FIELD CHANGE

OSCILLATOR, RADIO FREQUENCY

0-715B/URA-31

MODIFIES 0-715B/URA-31
CIRCUITS TO PROVIDE AUTOMATIC
CONNECTION OF 0-715B/URA-31
AS FREQUENCY STANDARD FOR
ASSOCIATED EQUIPMENT WHEN
EXTERNAL STANDARD FAILS

Figure 1. CSS, Top View

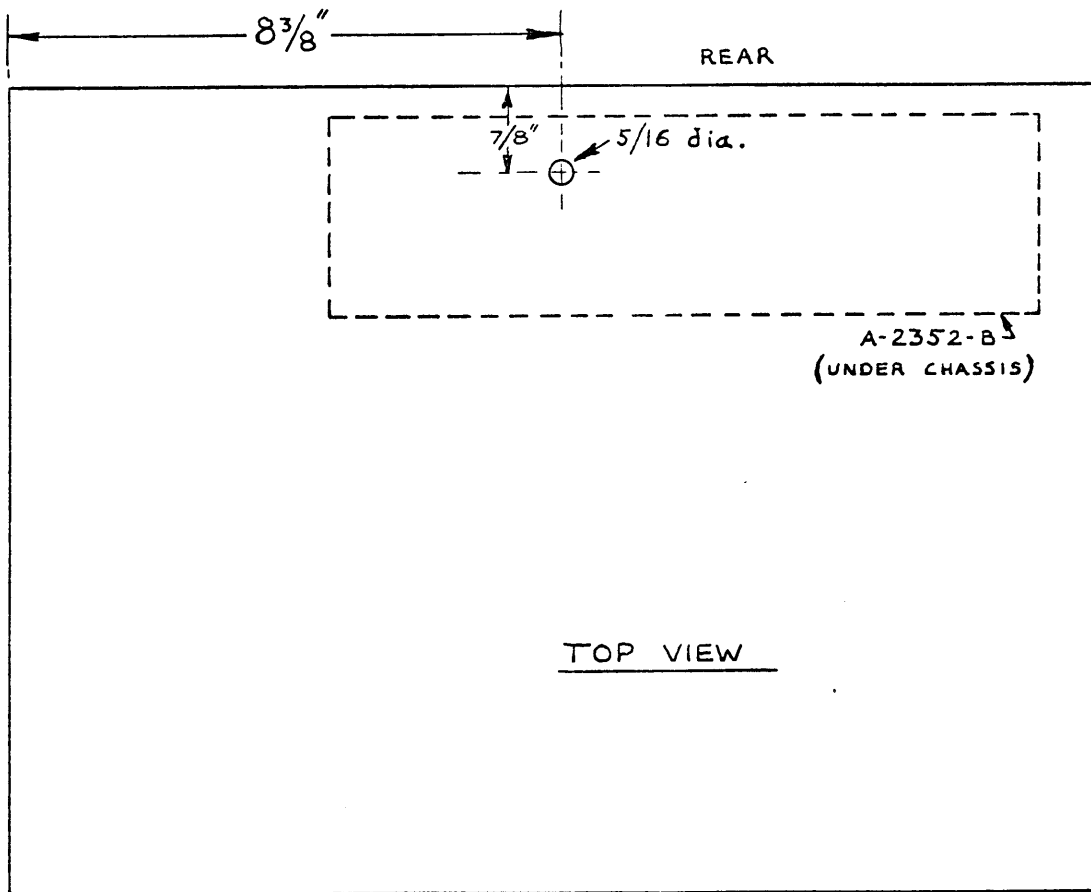
8. Use electric drill (item 6, table 2) and 5/16" drill bit (item 6, table 1) to drill 5/16" hole in chassis as shown in figure 1.
9. Press grommet (item 4, table 1) into 5/16" hole drilled in step 8.
10. Remove screws from positions labelled 1, 2, and 3 on figure 2.

Figure 2. CSS, Rear View

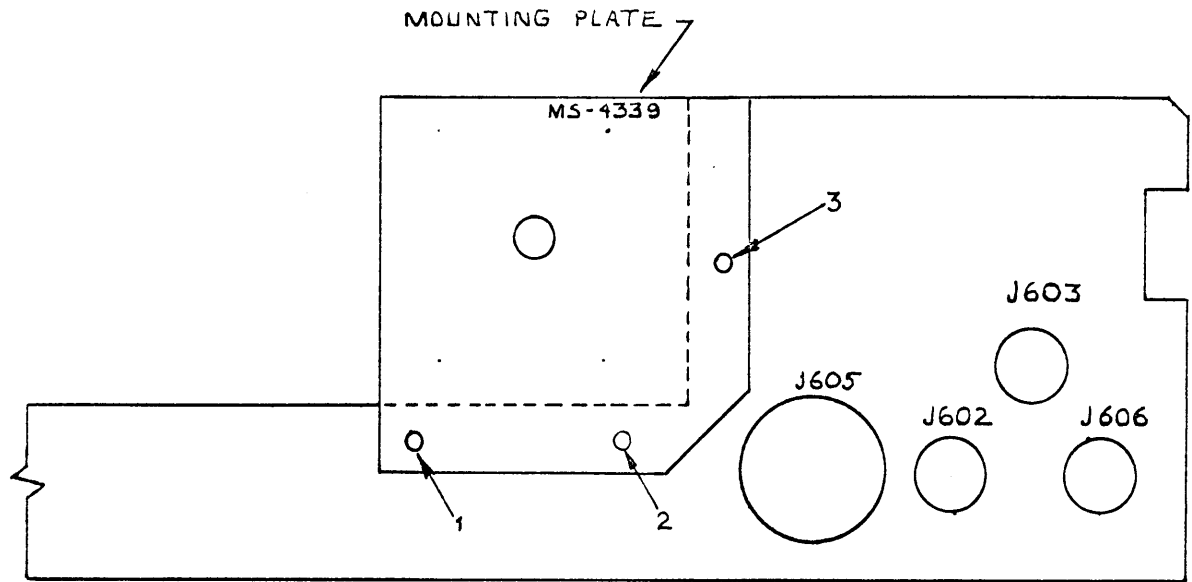
11. Affix mounting plate (item 3, table 1) in position shown on figure 2. Use original screws in positions labelled 1 and 2; use screw (item 11, table 1) in position labelled 3 on figure 2.

Figure 3. CSS, Bottom View

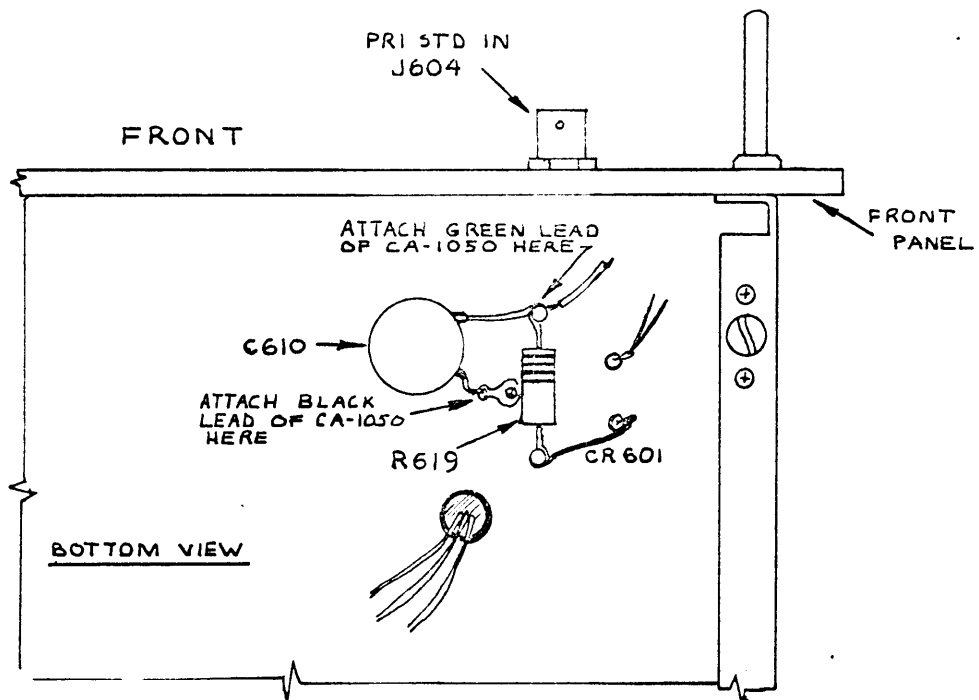
12. Press grommet (item 4, table 1) into center hole of mounting plate installed in step 12.
13. Refer to figure 3 for steps 13 and 14. Solder one end of green wire of CA-1050 (item 5, table 1) to standoff insulator at junction of R619 and C610.

14. Solder one end of black wire of CA-1050 to ground lug nearest R619 and CR601 on underside of chassis.
15. Route CA-1050 along existing wire harness; pass free end through grommet installed in step 9 to topside of chassis, then through grommet installed in step 12 to rear of chassis.

Figure 4. CSS, Top Cover, Rear View

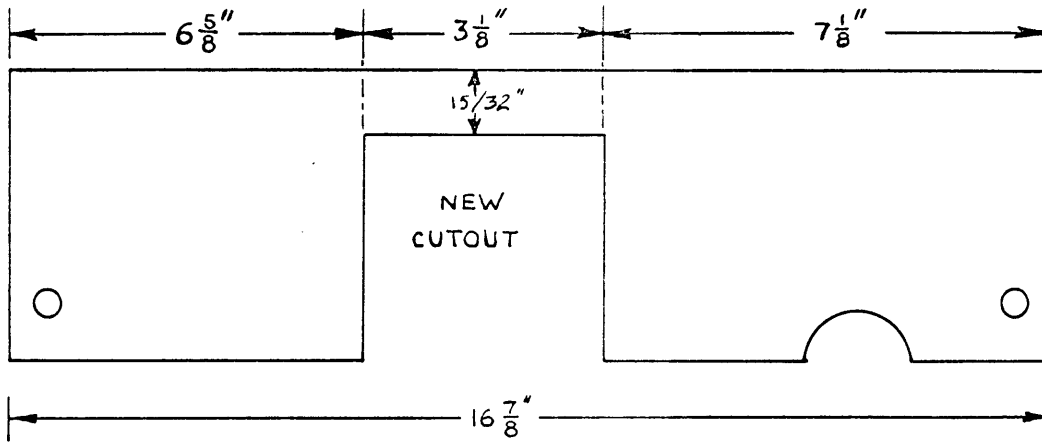
19. Refer to figure 4 and, using metal shears (item 9, table 2), cut CSS top cover to fit around AX-546.
20. Replace CSS top and bottom covers.
21. Using an identification plate (item 1, table 1) as a template, drill identification plate mounting holes directly below existing identification plate.

CSS-1C, Simplified Block Diagram

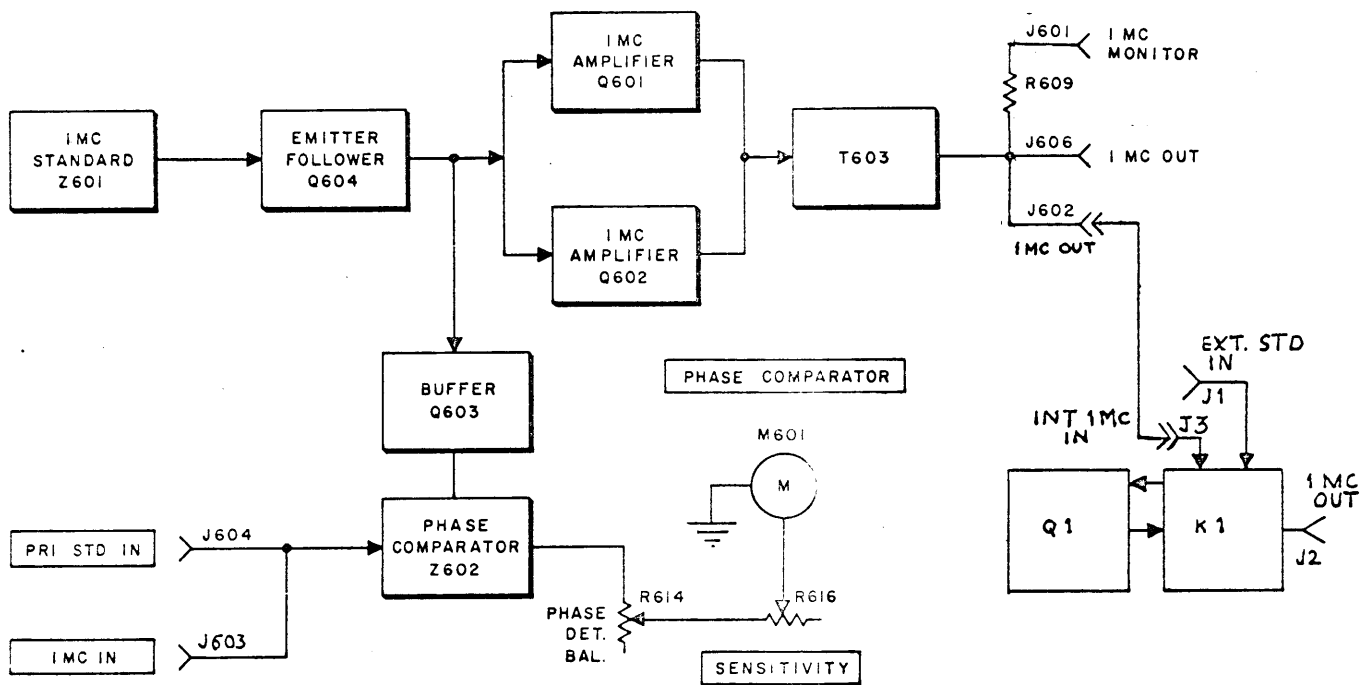
2. Make a copy of figure 4-1, page 4-0 in CSS-1B manual.
Retain this copy in support of equipments that have not been modified.
3. Paste CSS-1C Simplified Block Diagram supplied with this temporary correction over figure 4-1, page 4-0 in CSS-1B manual.
4. In CSS-1B manual, change all CSS-1B references to CSS-1C.
5. In paragraph 1-4, under Semiconductor Complement, add the following:
 - (1) 2N 1308
6. In paragraph 2-2c., change J602 to J2.
7. At end of paragraph 4-1, page 4-0, add the following: An automatic change-over relay automatically connects the CSS-1C as a frequency standard, to associated equipment if an external frequency standard input to the equipment fails.
8. At end of first paragraph within paragraph 4-2, page 4-0, add the following:

The 1-mc output from J602 is applied to INT 1-mc jack J3, and 1-mc from an external source may be applied to EXT STD IN jack J1. One of these two signals is coupled through relay K1 to 1-mc out jack J2.

If a 1-mc input is being applied to J1, relay K1 couples the signal from J1 to J2. If an input is not being applied to J1, transistor Q1 actuates relay K7, and the 1-mc input to J3 is coupled to J2.

Figure 8-1. Frequency Standard CSS-1C Schematic Diagram

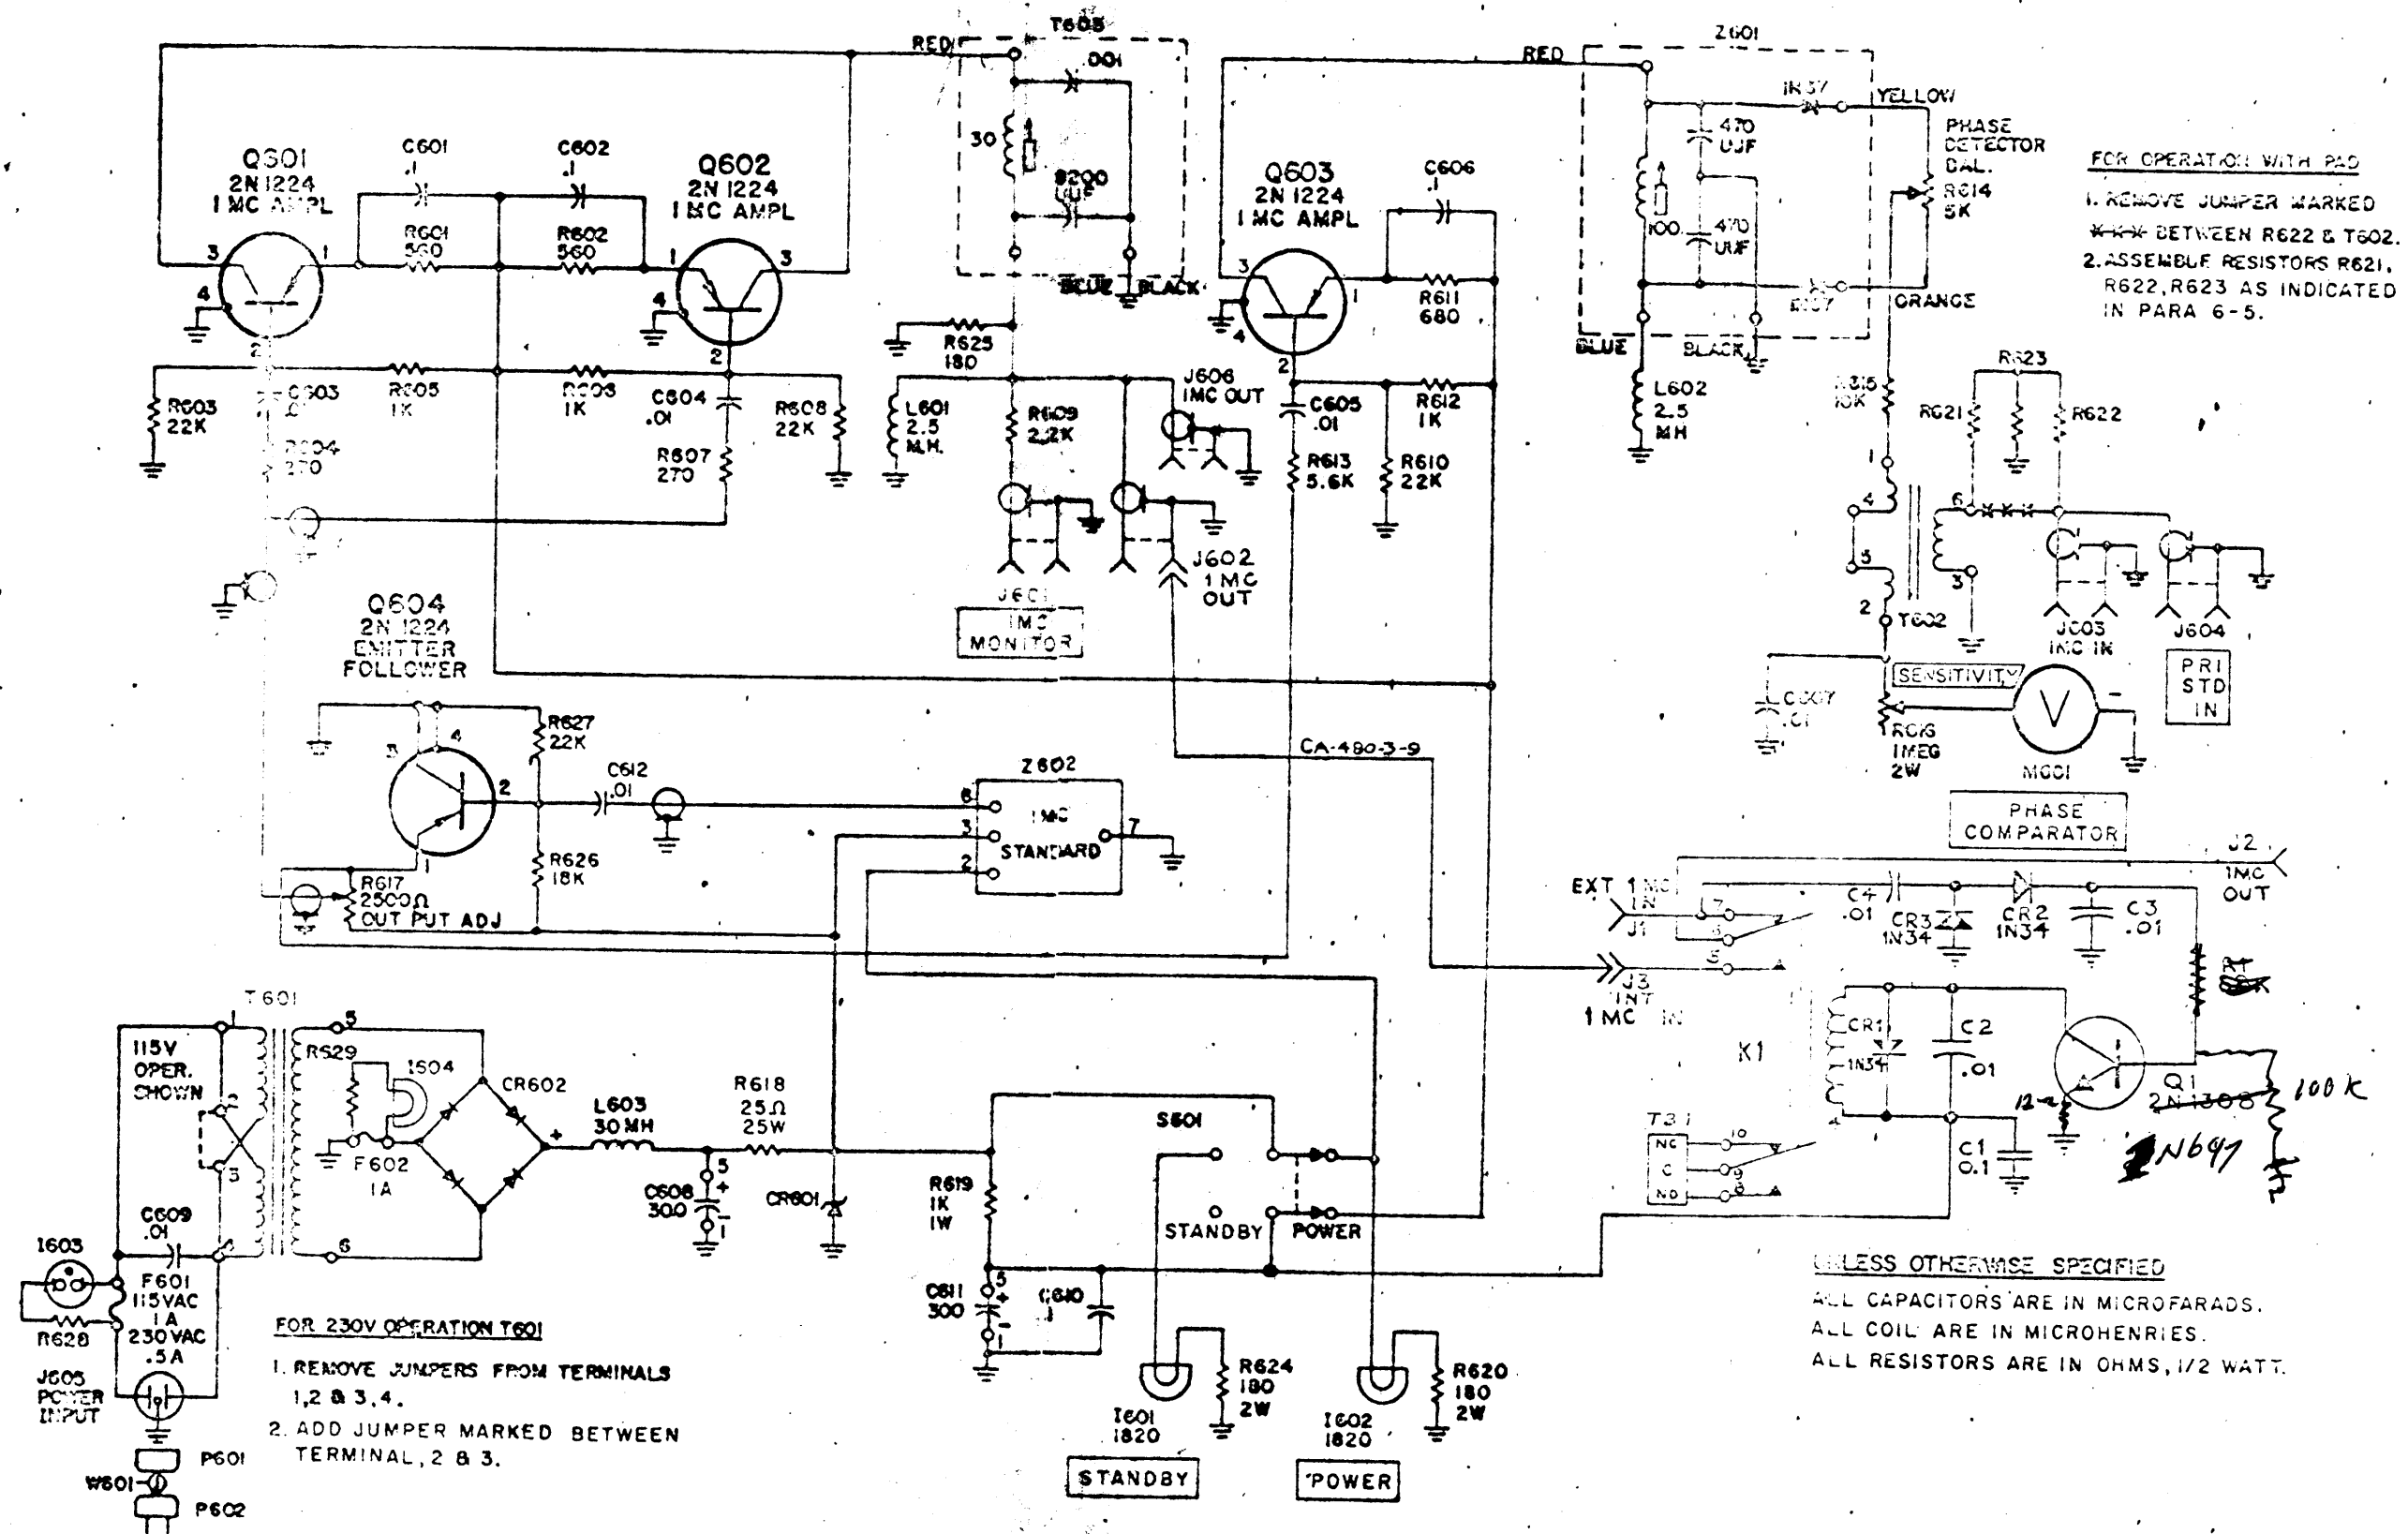
1. Remove figure 8-1 (pp8-3/8-4) from CSS-1B manual and insert new figure 8-1 supplied with this temporary correction. Keep removed figure 8-1 for support of equipments that have not been modified.
